SBÍRKA MEZINÁRODNÍCH SMLUV

42. Sdělení Ministerstva zahraničních věcí o přijetí konsolidovaného seznamu změn a doplňků k přílohám Evropské dohody o mezinárodní přepravě nebezpečných věcí po vnitrozemských vodních cestách (ADN)
-

ECE/ADN/36

**European Agreement concerning the International Carriage
of Dangerous Goods by Inland Waterways (ADN) ¹****Draft amendments to the Regulations annexed to ADN**

Figure 5.2.1.9.2

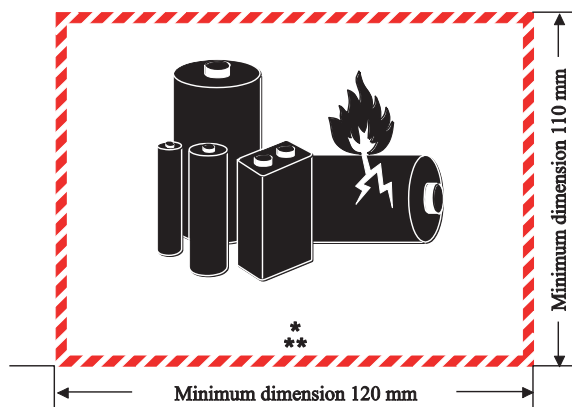
5.2.1 Add a new 5.2.1.9 to read as follows:

5.2.1.9.1 Packages containing lithium cells or batteries prepared in accordance with special provision 188 shall be marked as shown in Figure 5.2.1.9.2.

5.2.1.9.2 The mark shall indicate the UN number preceded by the letters “UN”, i.e. ‘UN 3090’ for lithium metal cells or batteries or ‘UN 3480’ for lithium ion cells or batteries. Where the lithium cells or batteries are contained in, or packed with, equipment, the UN number preceded by the letters “UN”, i.e. ‘UN 3091’ or ‘UN 3481’ as appropriate shall be indicated. Where a package contains lithium cells or batteries assigned to different UN numbers, all applicable UN numbers shall be indicated on one or more marks.

Legend

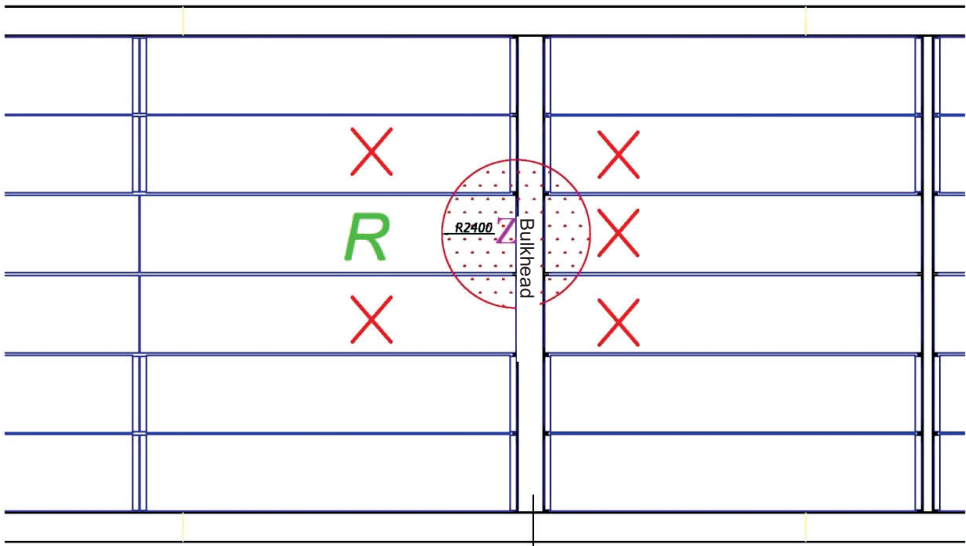
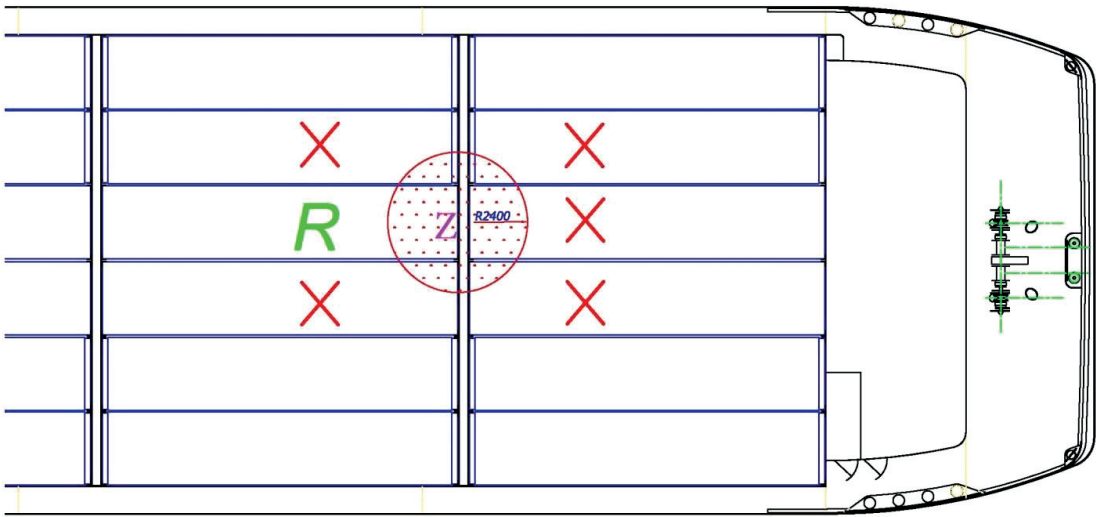
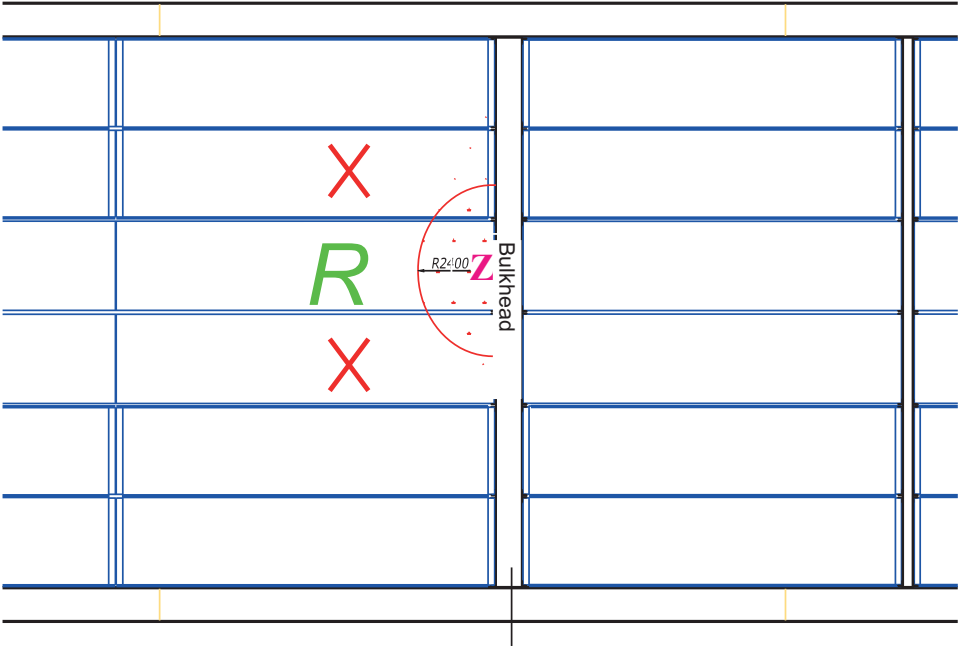
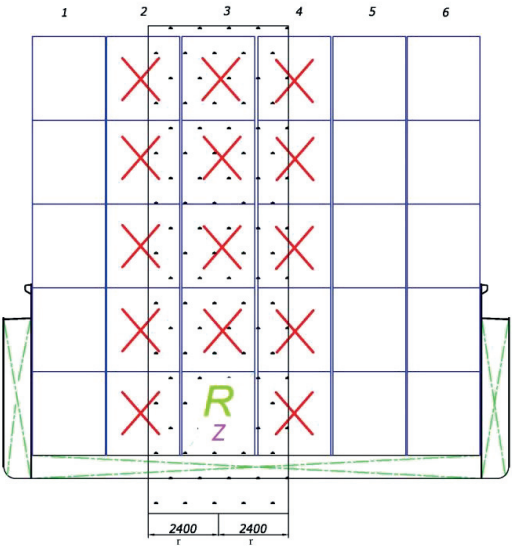
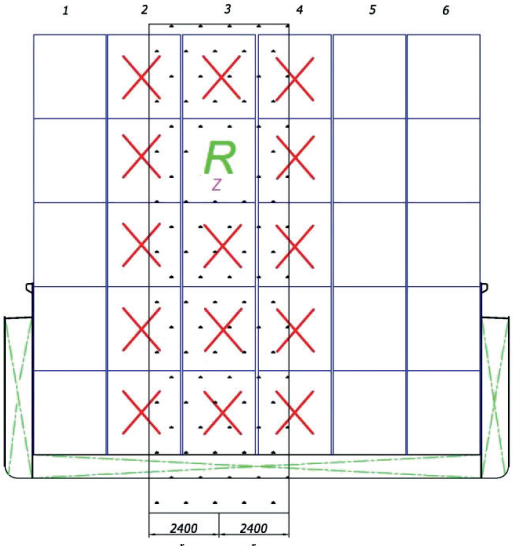
7.1.4 Insert a new 7.1.4.4.5 to read as follows:

“7.1.4.4.5 The electrical equipment fitted to an open container may not be connected with removable electrical cables in accordance with the provisions of 9.1.0.56 nor be put into operation unless it is of a certified safe type or the container is placed in a hold which does not contain containers with substances referred to in 7.1.4.4.4 (b).”.

Vysvětlivky

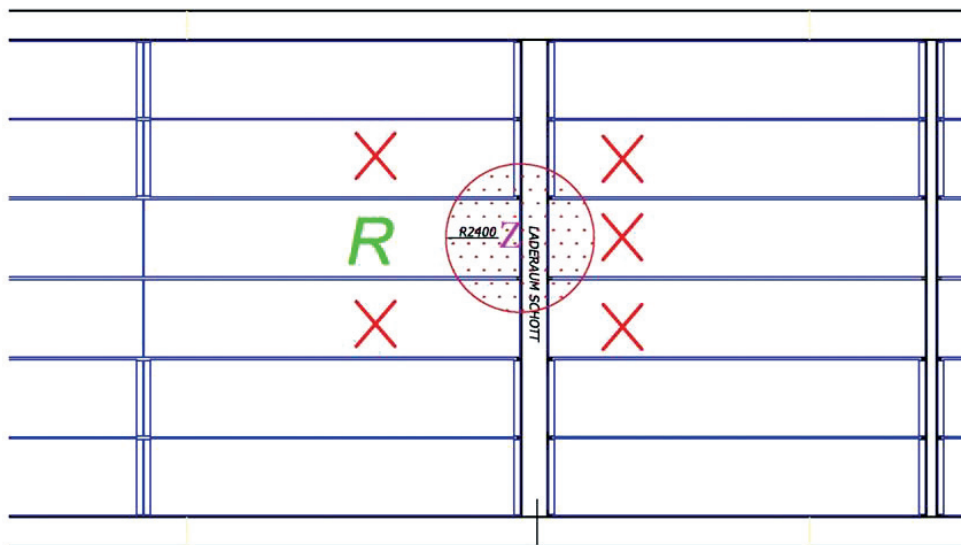
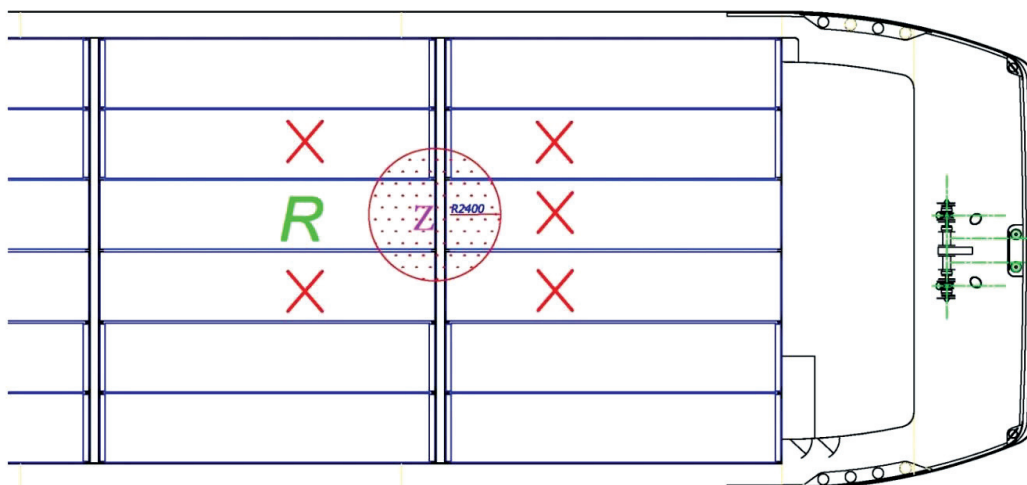
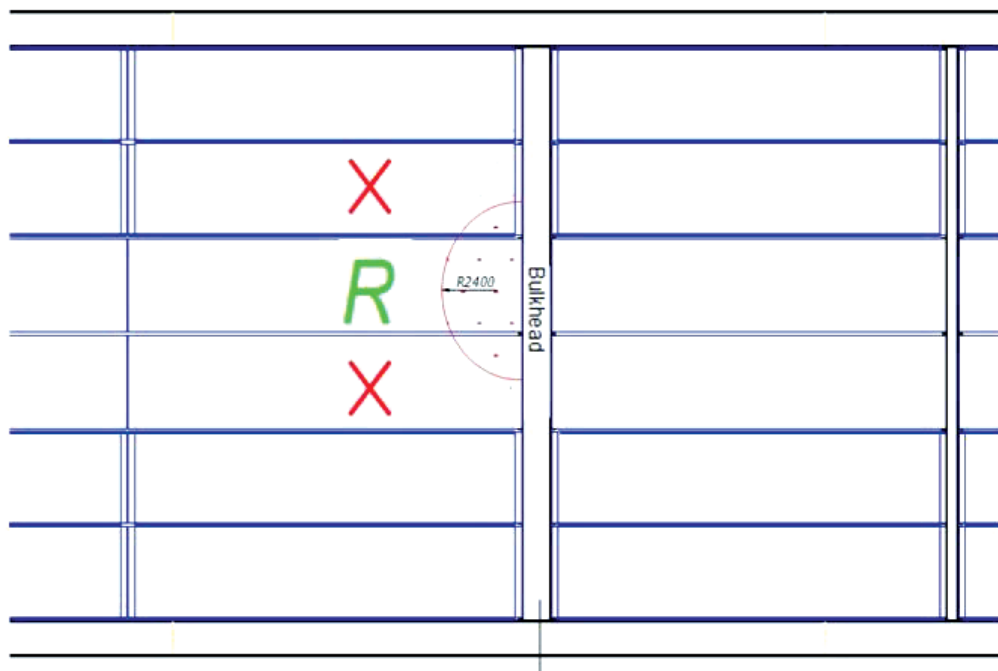
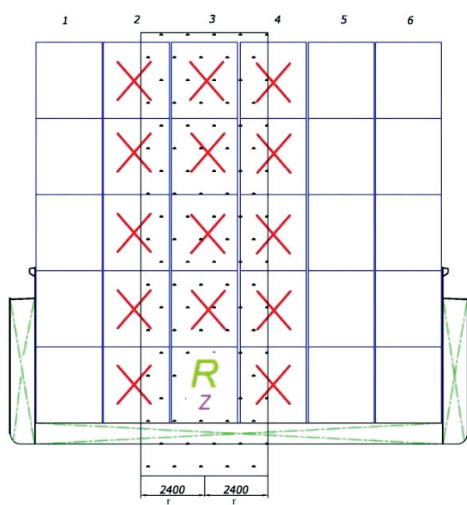
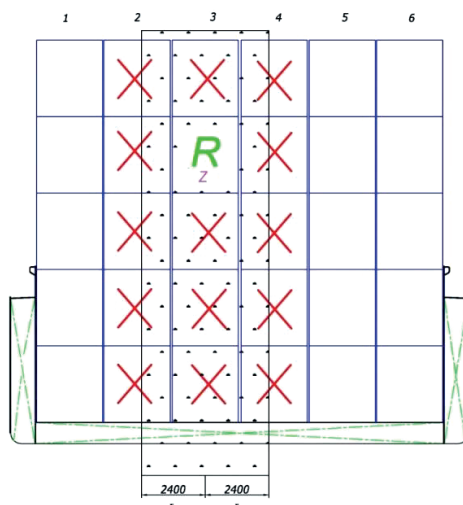
7.1.4 Vložit nový odstavec 7.1.4.4.5 v tomto znění:

„7.1.4.4.5 Elektrické zařízení namontované na nekrýtem kontejneru nesmí být spojeno s pohyblivými elektrickými kabely podle ustanovení uvedených v 9.1.0.56, ani být uvedeno do provozu, ledaže je typu
